**CITY OF WEST DES MOINES  
BOARD OF ADJUSTMENT COMMUNICATION**

**Item:** Ross Dress For Less Sign Variance, 4100 University Avenue, Suite 125 – A variance of the total amount of allowed tenant building signage from 240 sf to 371 sf (a 131 sf variance) – Ross Dress For Less (VAR-003913-2018)

**Requested Action:** Applicant requests approval of a variance of the maximum amount of building signage allowed for their tenant space to increase the building signage from 240 sf to 371 sf (a 131 sf variance).

**1 REAR • EAST • 36TH STREET • ELEVATION**

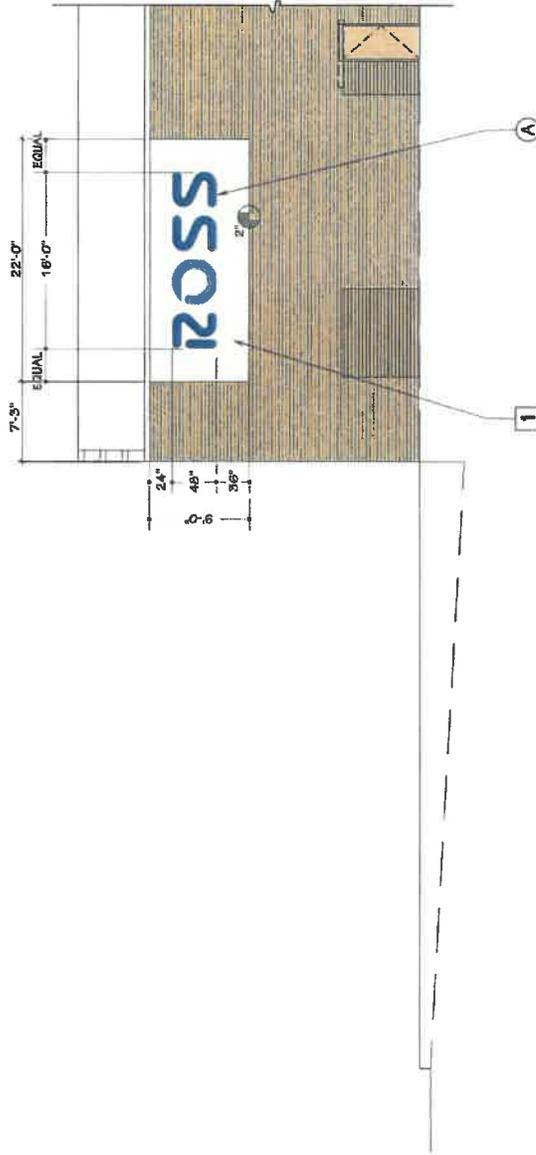
*Architecture Approved with Minor Modification:* As noted above, a Minor Modification was approved in 2017 to modify the architecture of the building to divide the former Sports Authority space into three tenant spaces, with Ross occupying the center portion of the space (Ulta is in the norther portion and the southern portion is currently vacant). With the sign proposal that has been submitted for Ross Dress For Less, they have proposed placing a 4'x16' sign (64 sf) in the rear of the tenant space facing east towards the Home Depot parking lot. The applicant has shown this sign being placed on a 9' x 22' white field labeled "Sign Fascia by Landlord" (see Attachment D – Signage proposal, sheet S2). The architecture package that was approved with the Minor Modification did not include any modifications to the rear of this tenant space. The landlord has indicated to staff that should the requested sign variance get approved, they would submit a new Minor Modification for this architectural addition. Staff would note that placing signage on the rear of the building could be allowed, however there is no additional sign area earned for the rear of the building so any sign area allocated to the rear of the building, would typically need to be deducted from the sign allowance earned by the front of the building. This would also be the first tenant within the complex to place a sign on the rear of the building. The other building signs that have been proposed in the applicant's sign proposal are all located on the west (front) of the building and include; the main sign (291 sf), an eight (8) square foot "Ross" wall plaque, and a 7.67 square foot projecting sign mounted adjacent to the front door.

*The property is commercial in nature so signage would not be out of character with the site or its surroundings except that a sign on the rear of the building would be out of character with the development, however it would not be considered to have a detrimental affect on the environment.*

1. Subject to the condition that a minor modification to the building architecture is submitted and approved for the changes to the east side of the tenant space of the applicant.
